## ADDENDUM No. 3: October 04, 2017

PROJECT: EAST JEFFERSON GENERAL HOSPITAL  
CARDIAC CATHETERIZATION LAB C RENOVATION  
4200 HOUMA BLVD.  
METAIRIE, LOUISIANA 70006

PROJECT NO.: STBA 41197.31

##### **DRAWING SHEET D102**

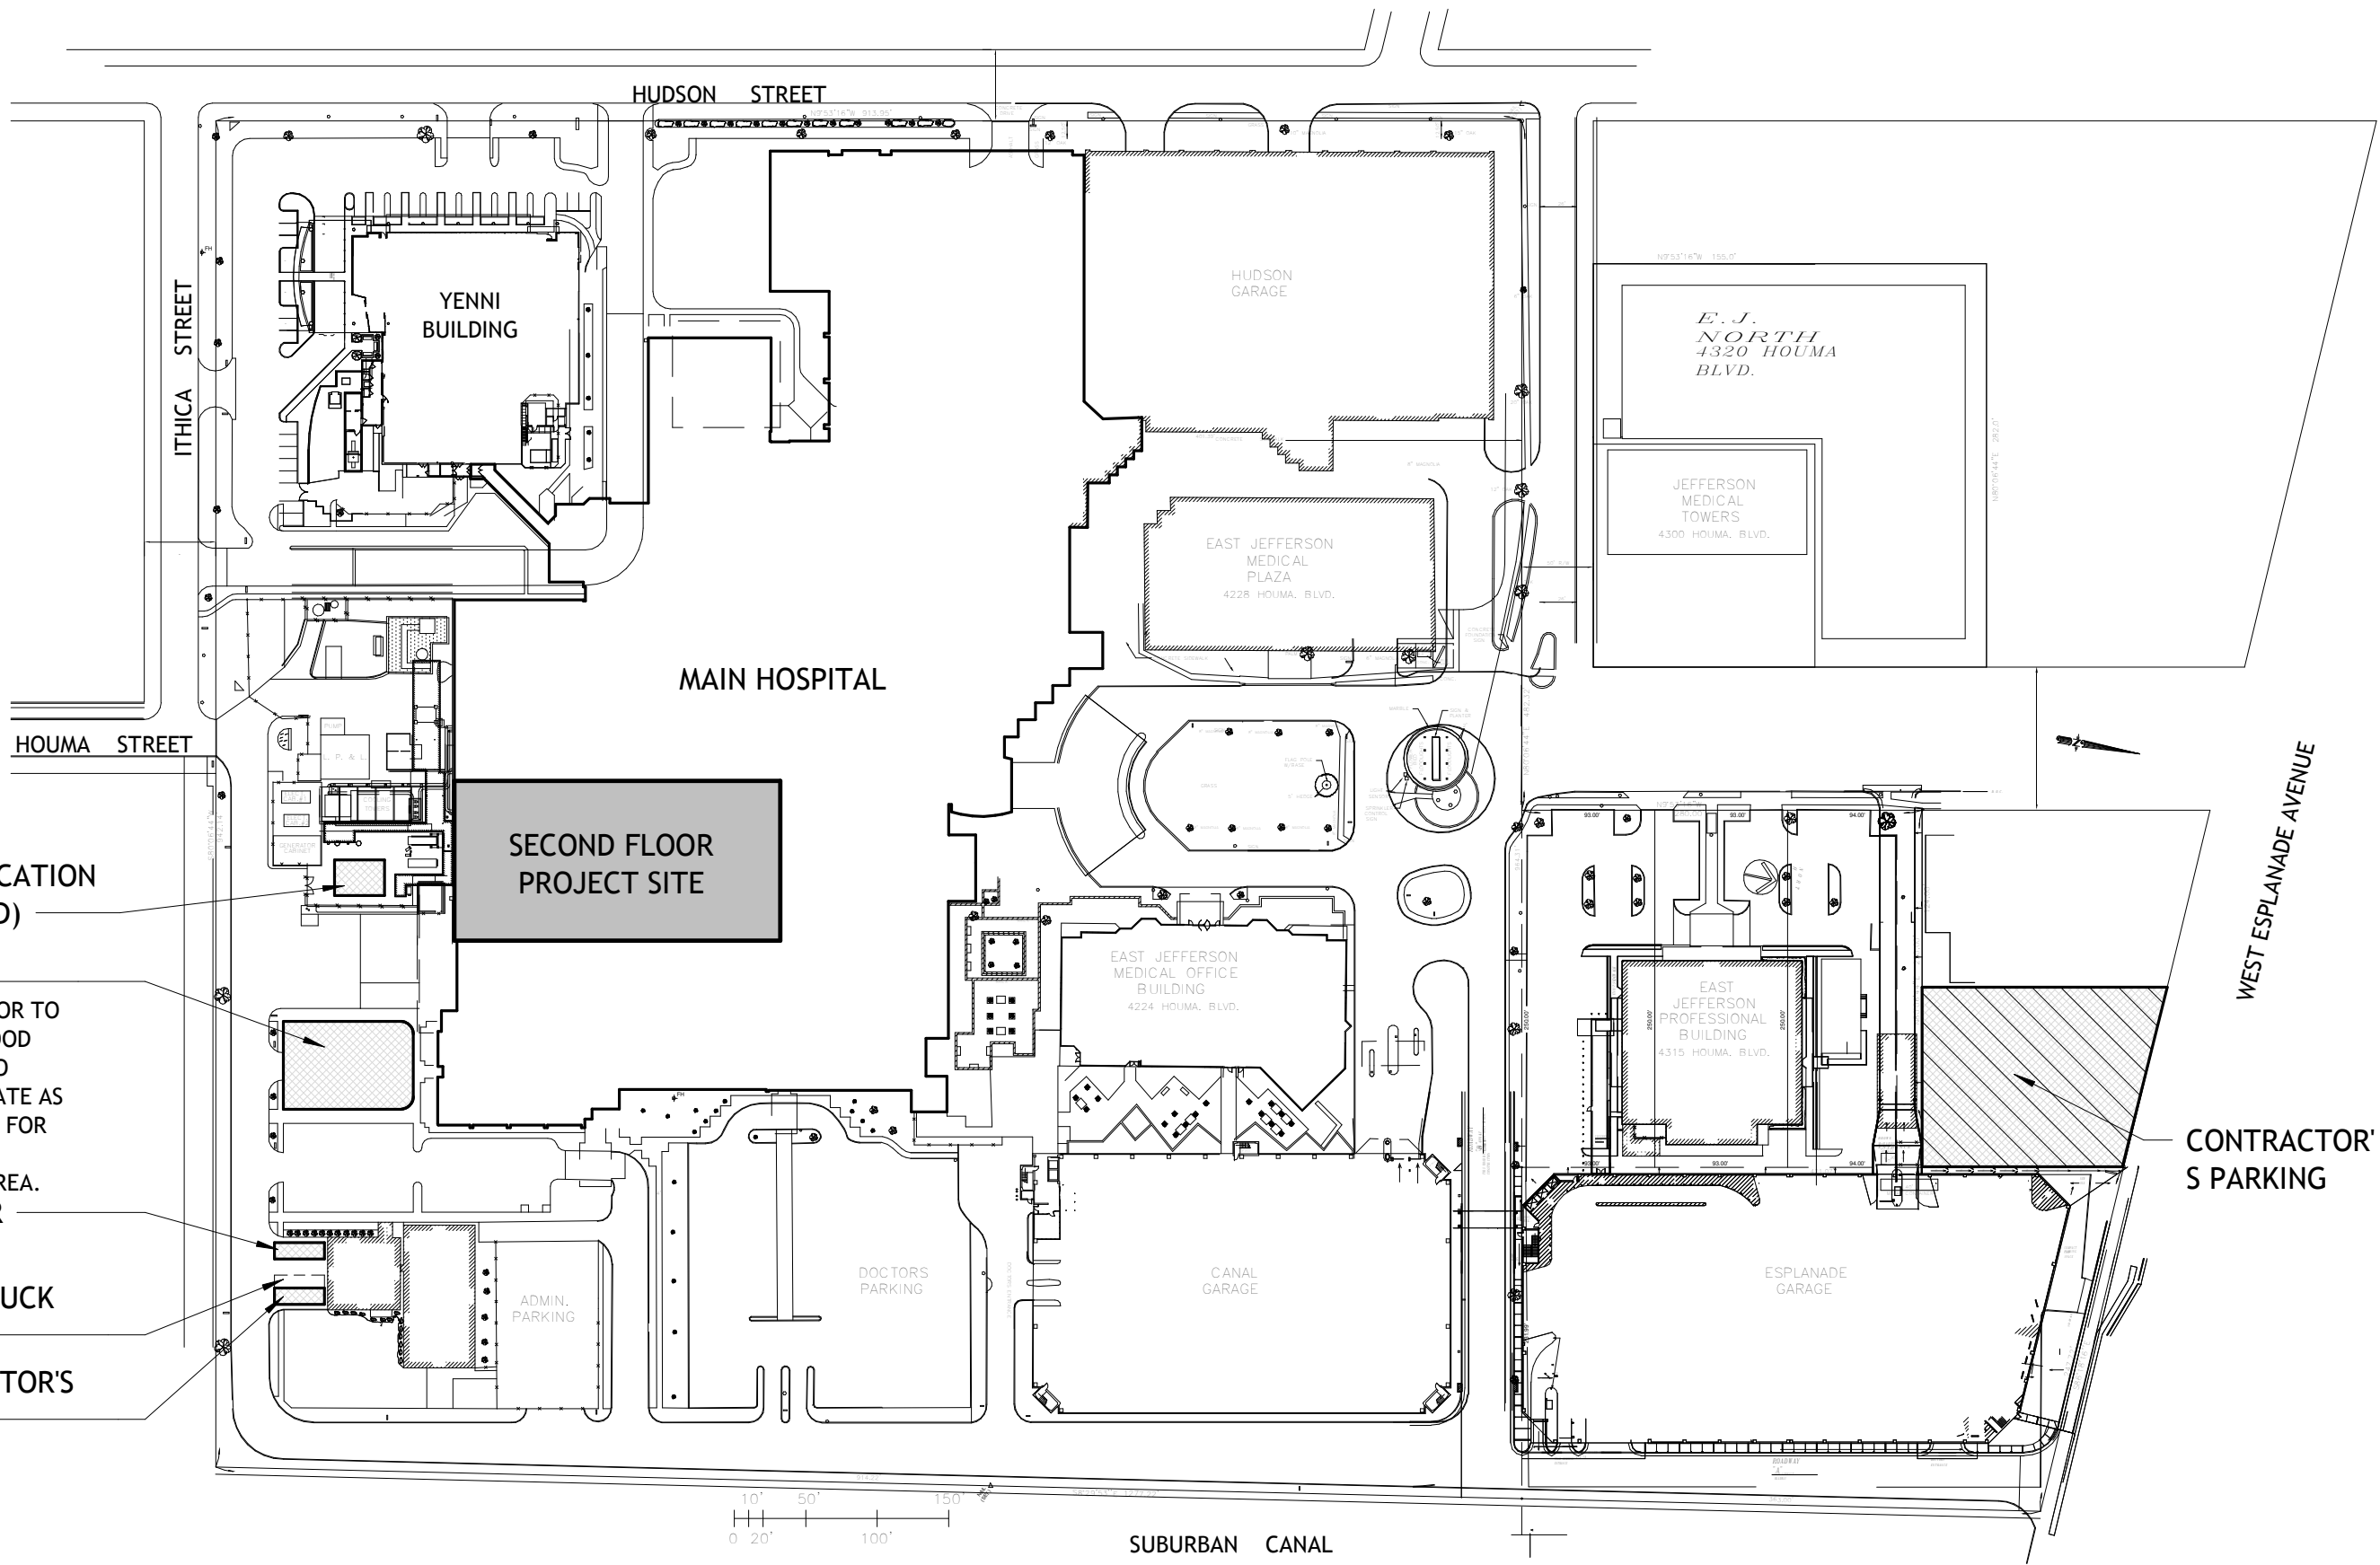
12. Delete note #12 temporary dust partition between the Cath Lab C 202 and the Control Room 203.
13. Change the material for doors 201 and 113D to S.C. Wood.

**1 SITE PLAN**  
**ASK-01** 1 : 1450

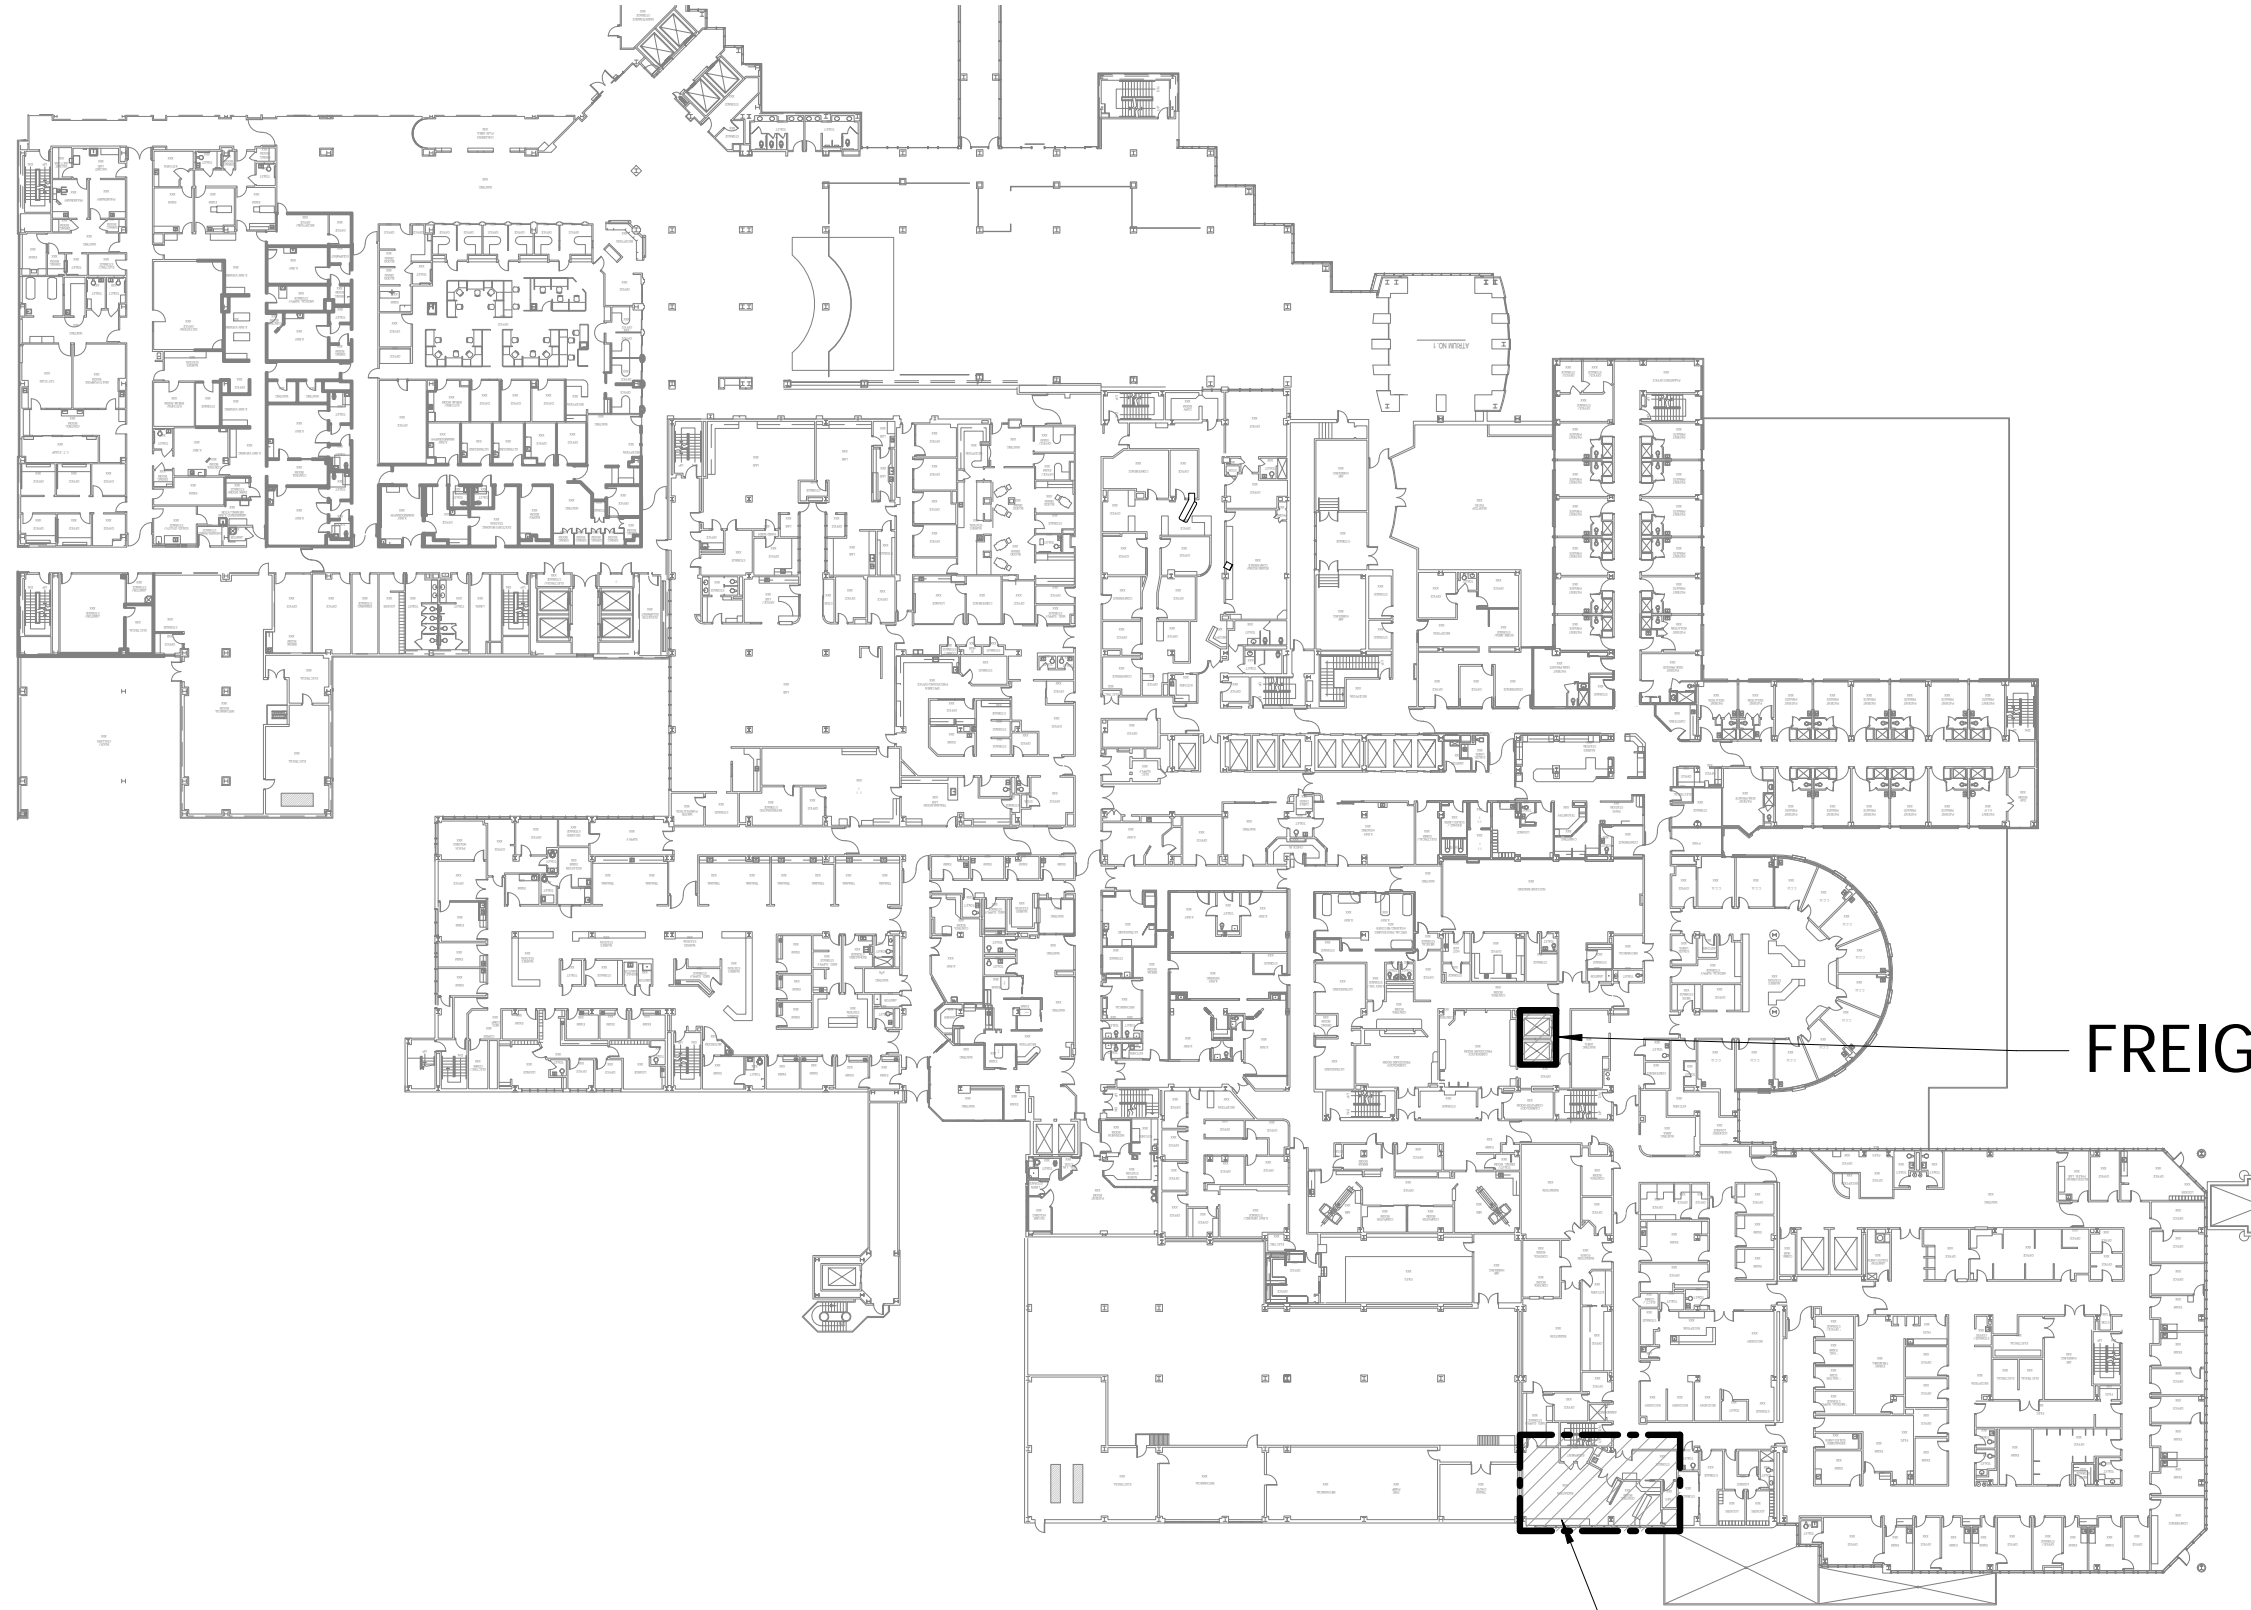
- CRANE LOCATION (IF NEEDED)
- STAGING CONTRACTOR TO MODIFY WOOD FENCING TO PROVIDE GATE AS NECESSARY FOR ACCESS TO STAGING AREA.
- DUMPSTER
- SINGLE TRUCK PARKING
- CONTRACTOR'S TRAILER
